FORM P3: ADMINISTRATIVE DECISIONS AND MINOR AMENDMENTS

The Applicant is requesting an update to the existing Site Plan-DRB for minor revisions to certain sidewalk configurations, transformer locations, maintenance building, clubhouse building height, etc.

RE: Request for a Minor Amendment to a Site Plan – DRB

The purpose of this letter is to request a Minor Amendment to the existing Site Plan-DRB for the property located at 6700 Modesto Avenue NE. The Applicant is requesting an update to the existing Site Plan – DRB for minor revisions to certain sidewalk configurations, transformer locations, maintenance building, clubhouse building height, etc. The current Site Plan was approved by the Development Review Board (DRB) on May 5, 2021 (Project #PR-2019-002761).

ELEVATIONS BUILDINGS TYPE I
 SHEET NO. **A4.11**
 20213

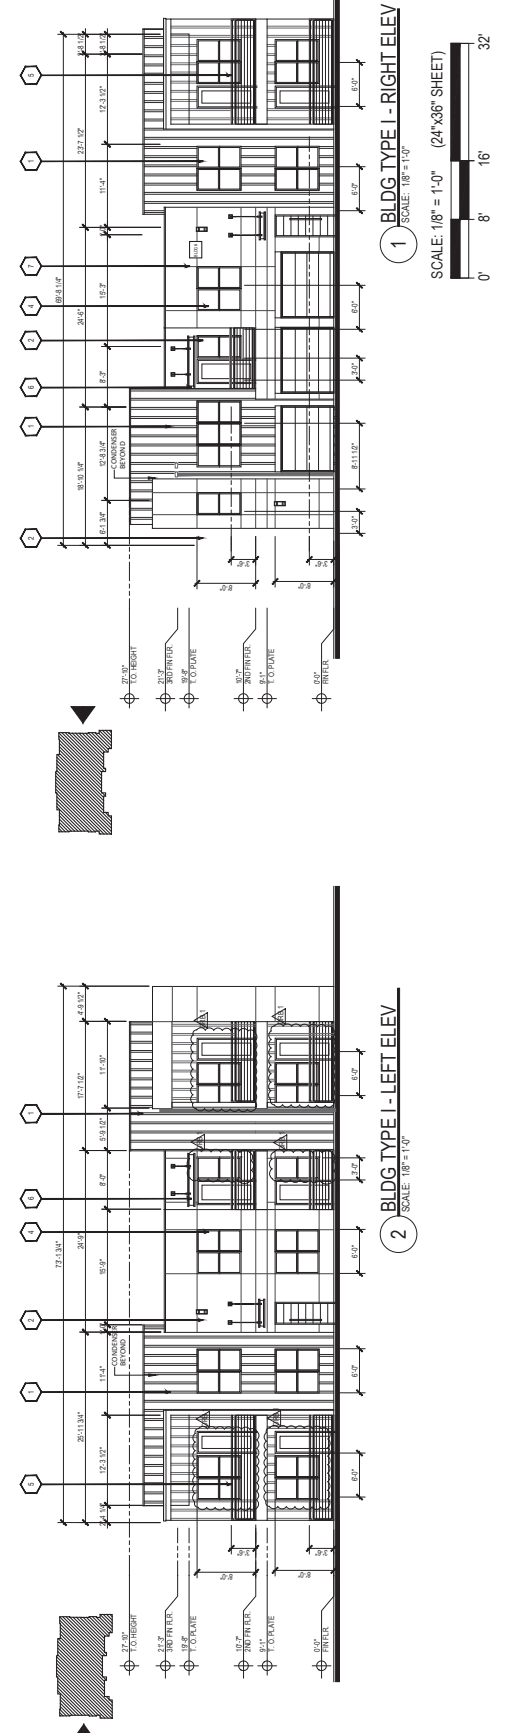
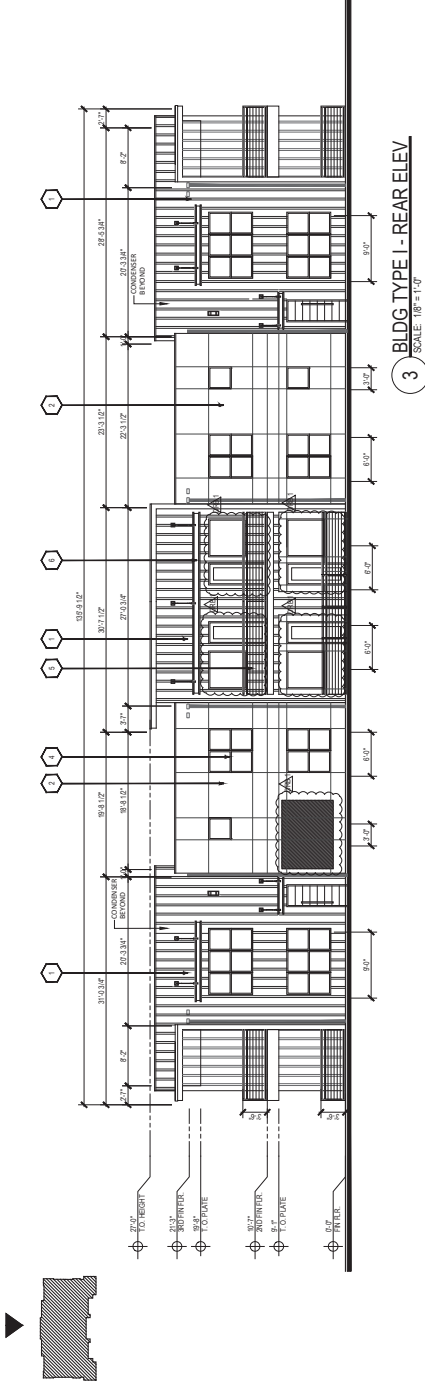
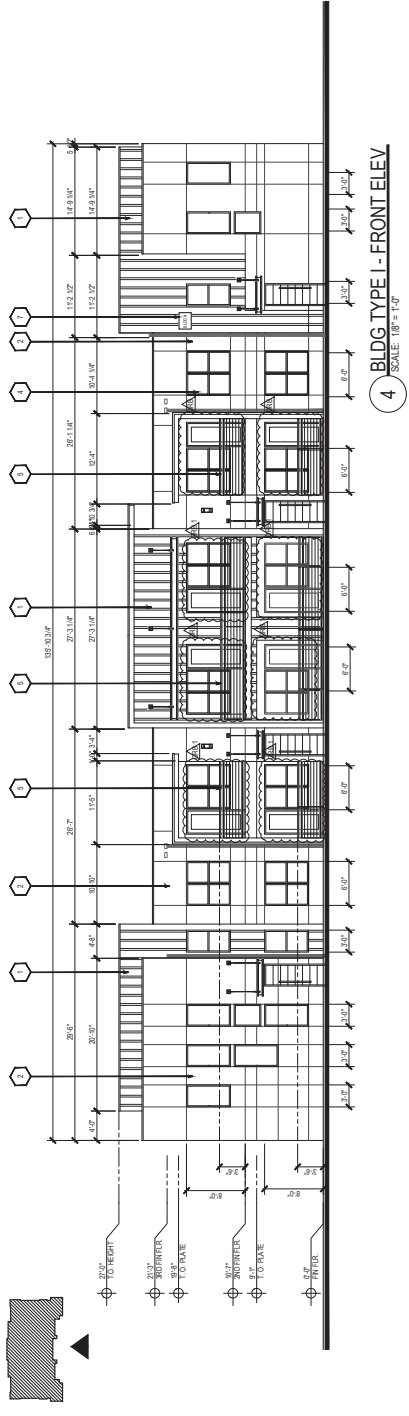
A4.11, 21, 31, 41 Building Type I, II, III, IV Building Elevations

- Updated windows, added meter locations.

SHEET NO.
A2.01

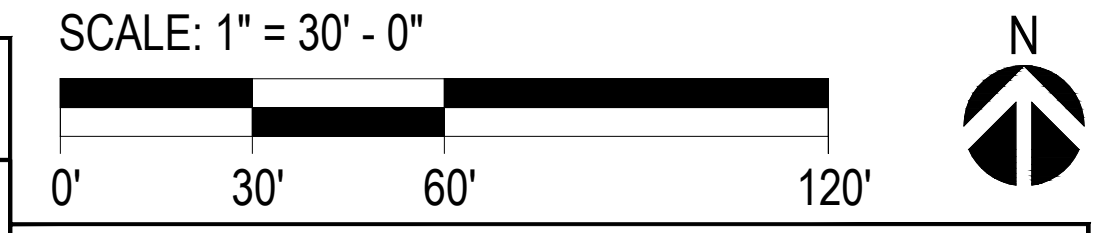
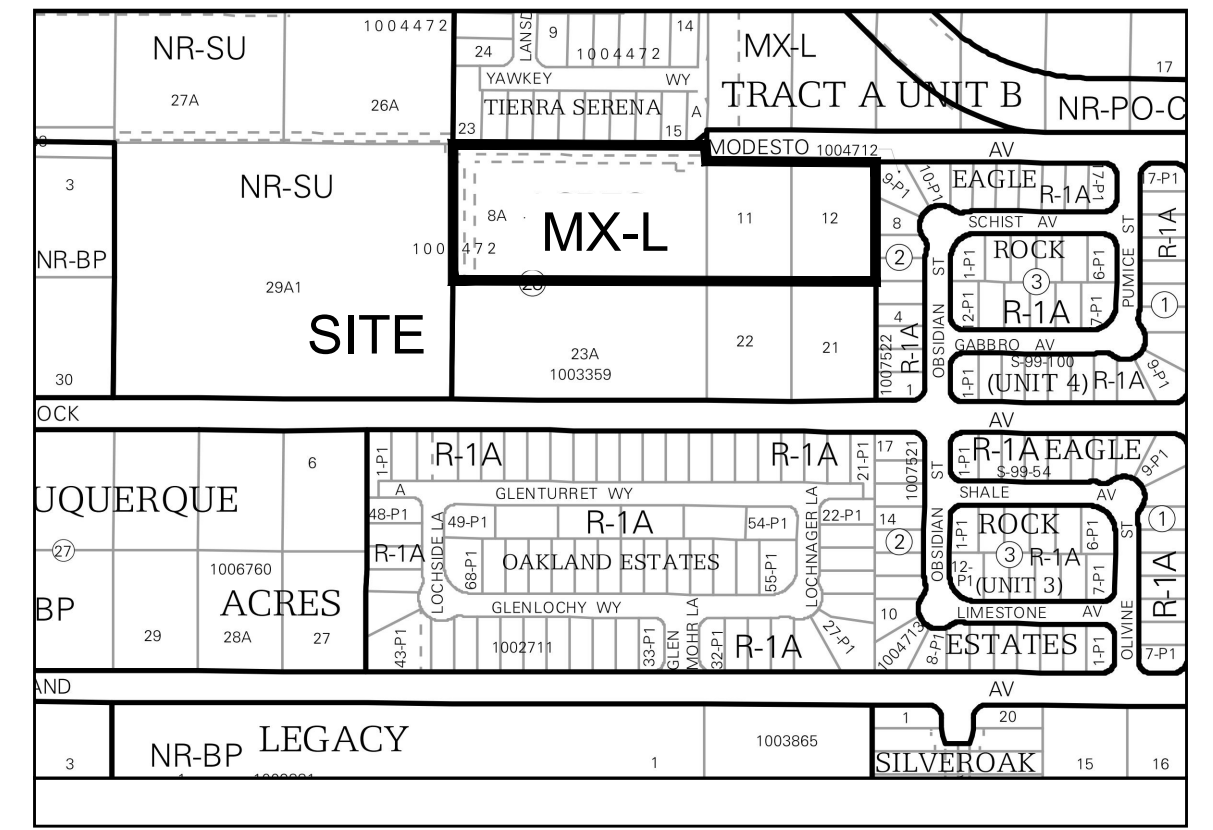
A2.01 Site Plan

- Maintenance room has been added.
- Single sidewalks between facing buildings have been switched to double sidewalks to provide accessible route.
- ADA parking on the north side has been relocated under carport.
- New ADA parking has been added adjacent to Dog Spa.

- Transformers between building #5 and #6 have been centered between the new double sidewalks.
- New sidewalks steps and ramps have been added to provide accessible route.
- Keynote #35 has been updated.
